# Leland Reservoir Replacement Project Final Environmental Impact Report

## Volume III – Responses to Comments

SCH #2016082082

Volume III

## Site-Line Diagrams

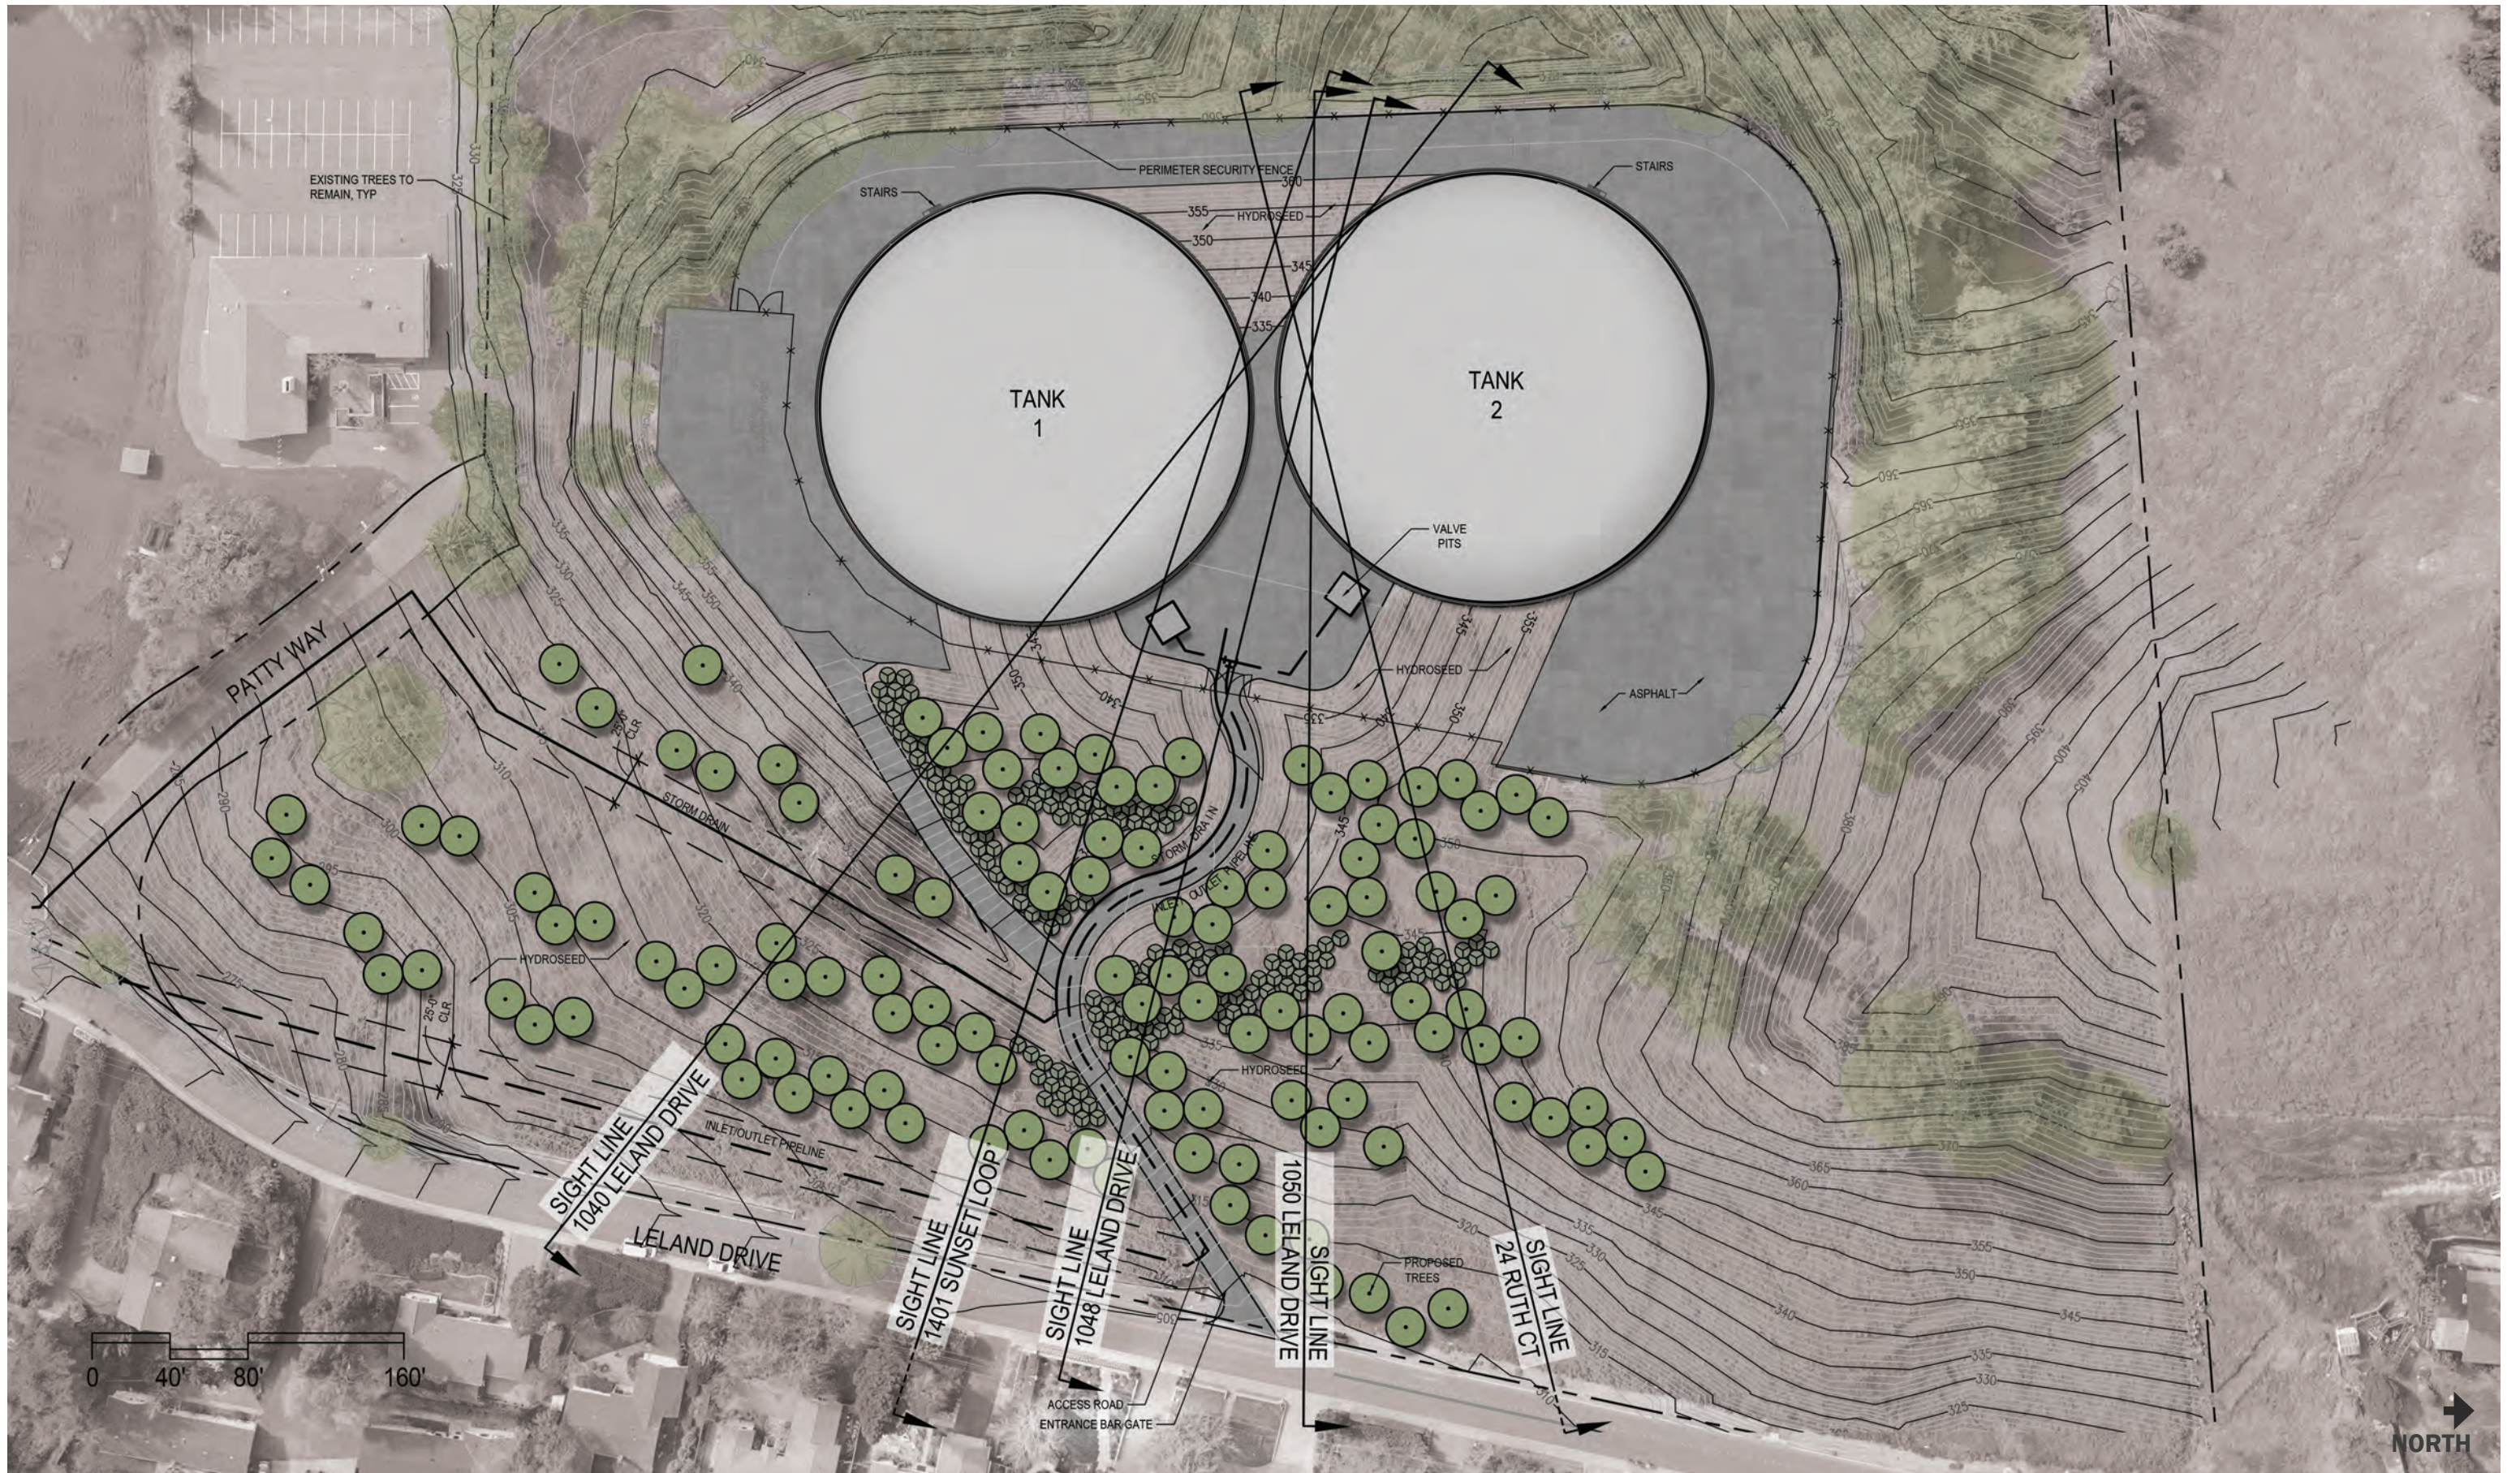
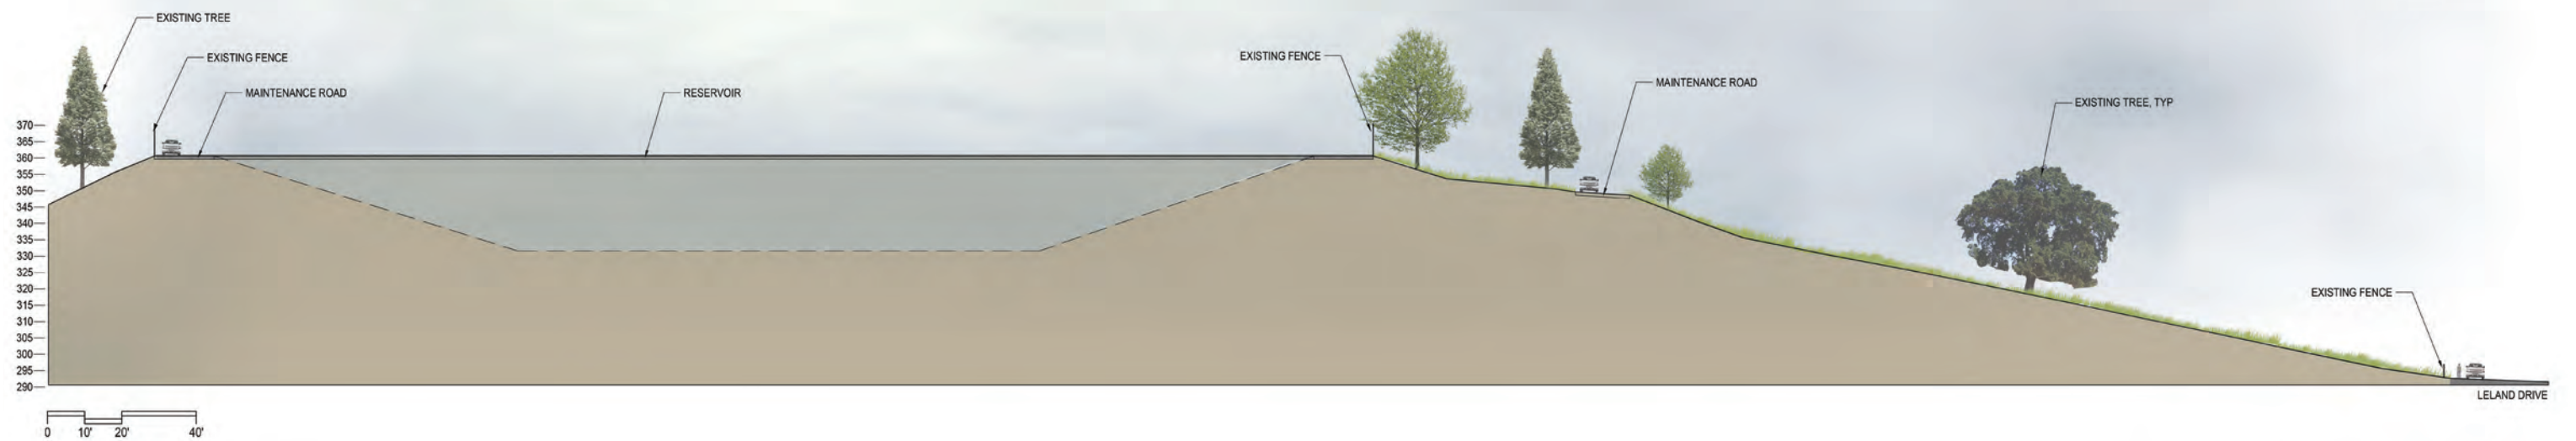
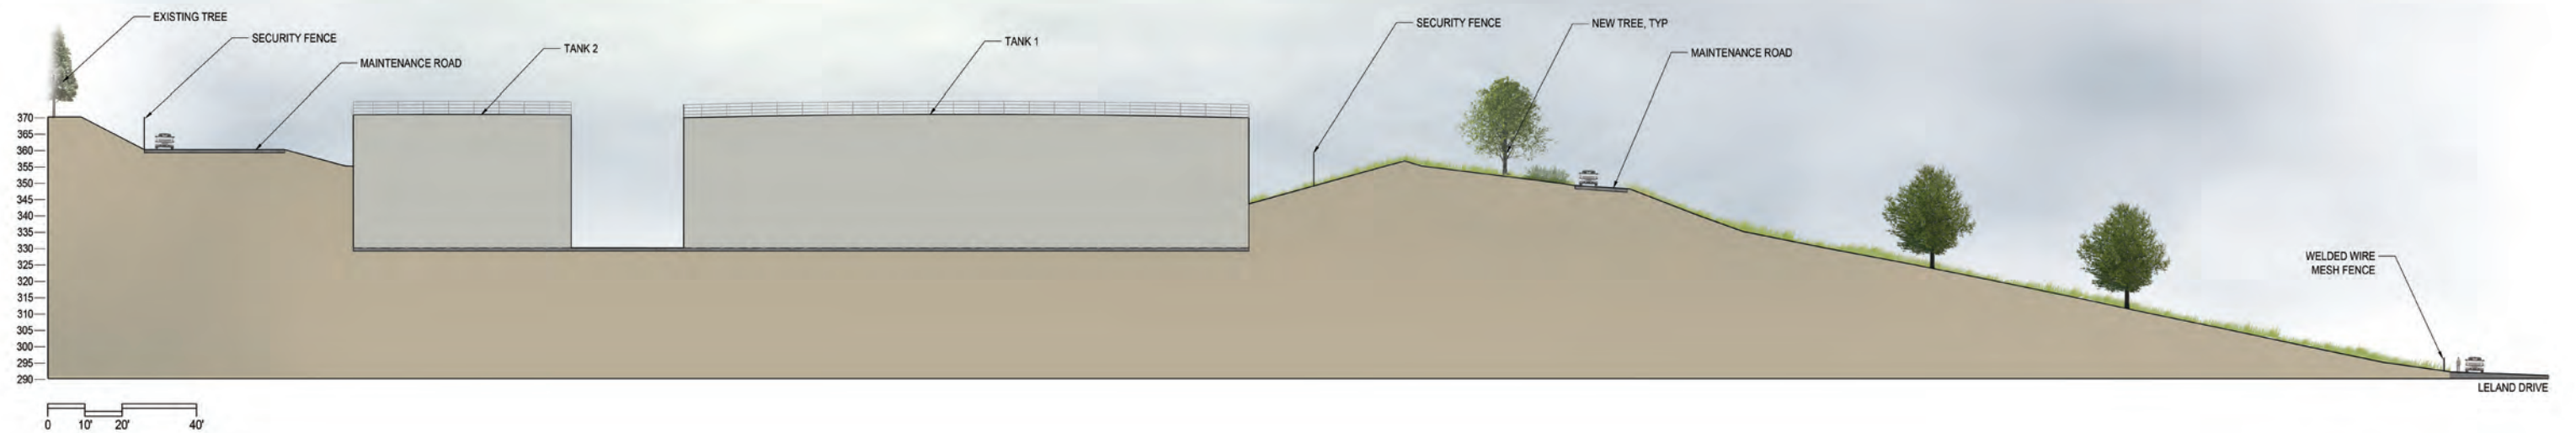
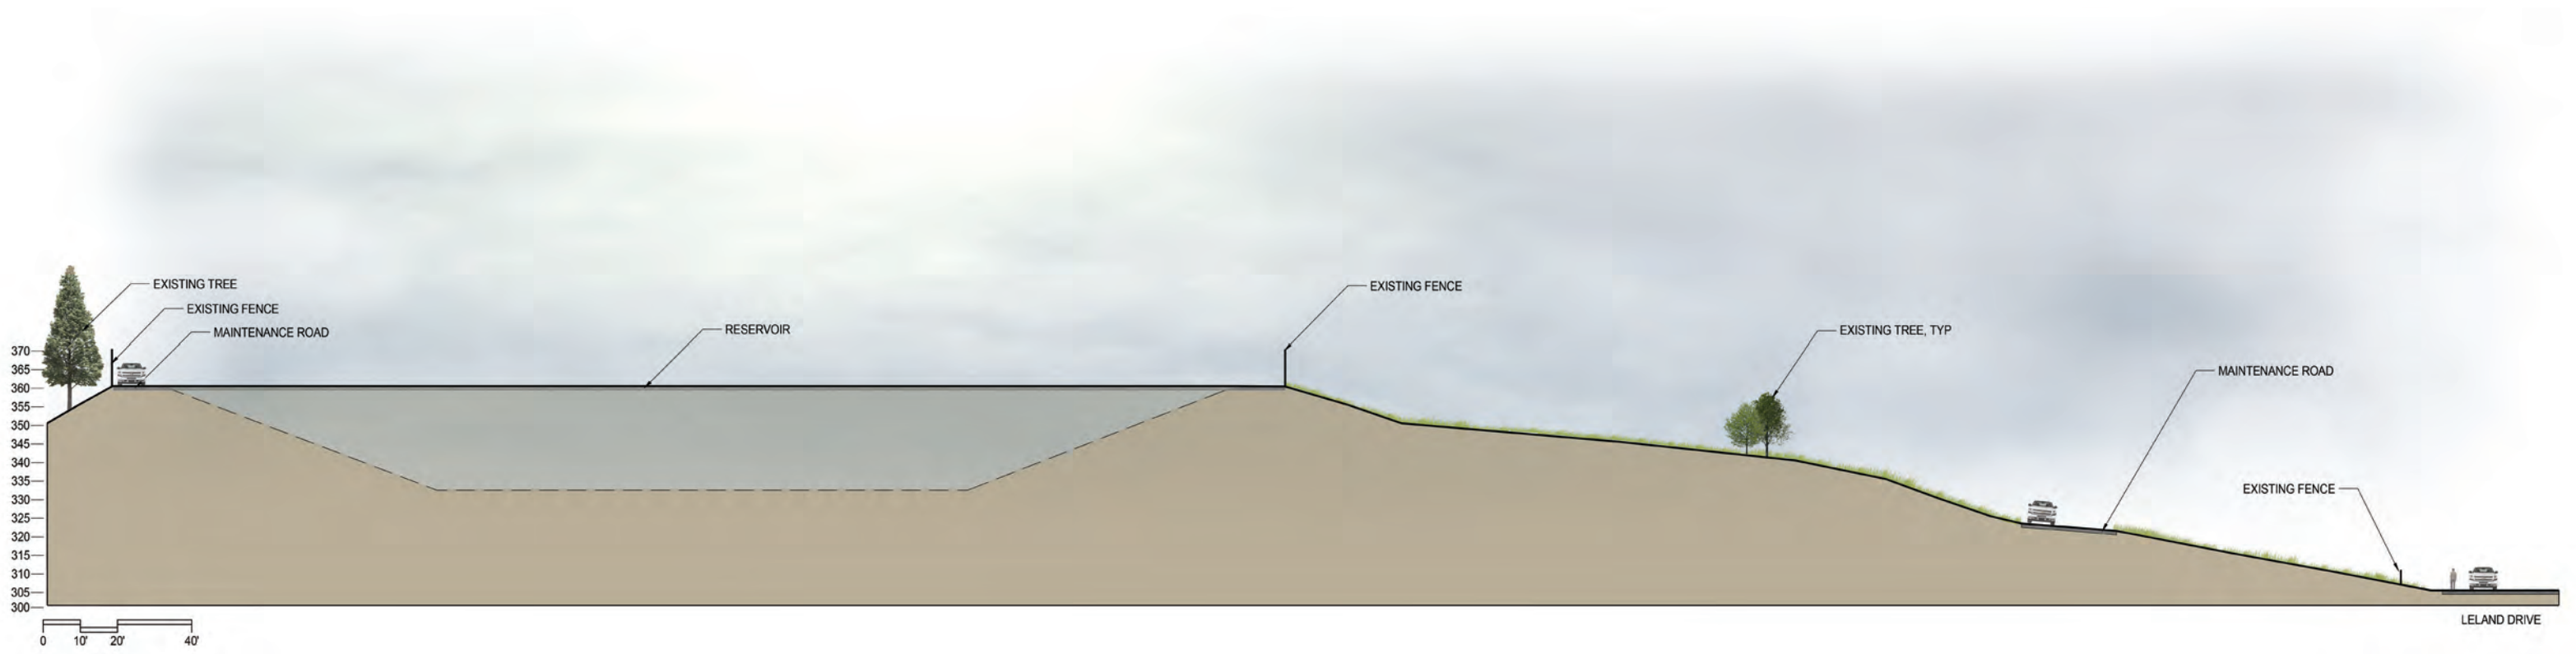
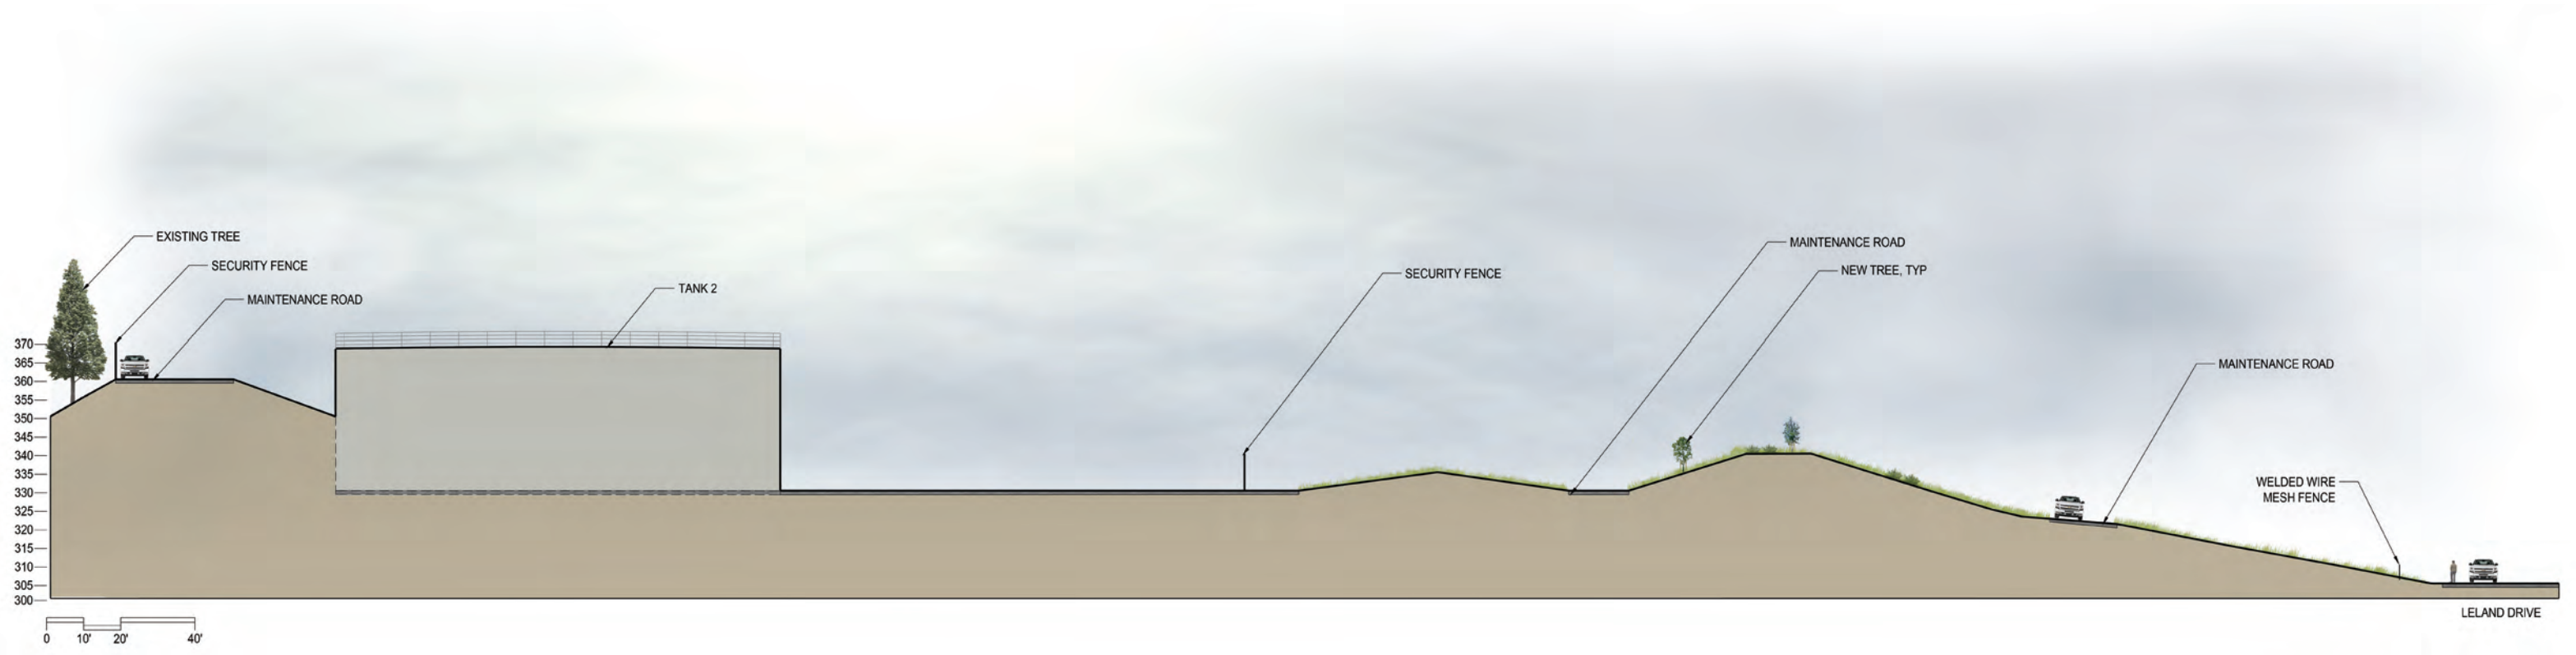
Comments have suggested that there would be a 280-foot wide valley in the middle of the existing embankment that would be visible from Leland Drive; however, no such view would exist. The access gate into the basin would not be visible from Leland Drive, and because the reservoir basin would be screened by topography, and plantings of new shrubs and trees, the new tanks are not expected to be highly visible from Leland Drive. Please refer to the end of this Master Response starting on page 9-9 for visual simulations that show the reservoir from several viewpoints, including three different angles from homes on Leland Drive to the east of the site. The visual simulations presented in this Master Response include Project conditions from immediately after construction to fifteen years after construction, and fully document the projected visual impacts of the new tanks and demonstrate that the entire height of the tanks would not be visible from Leland Drive.

In addition to the updated visual simulations, sight-line diagrams have been prepared for each of the three Leland Drive viewpoints listed above (three viewpoints on Leland Drive) and is included at the end of this Master Response starting on page 9-41. The sight-line diagrams illustrate a “slice” from each viewpoint through the Leland Reservoir site and demonstrate how topography and landscaping would screen the tanks. The location of each slice is shown on a site plan; note that the locations were selected to depict low-points in the topography where the tank would be most visible from nearby viewpoints. Because the slices do not go through the center of the tank, the full diameter of the tank is not shown.

At no time after construction would there be views from Leland Drive into the interior of the reservoir basin; the tanks would always be substantially screened from public viewpoints by topography. Sight-line diagrams presented at the end of this Master Response (pages 9-41 through 9-58) also demonstrate how topography of the post-construction embankment would substantially screen the tanks from view. Only the top of the tanks would be visible immediately following construction and the tanks would be screened by vegetation, which would almost totally hide the tanks within five years following construction.
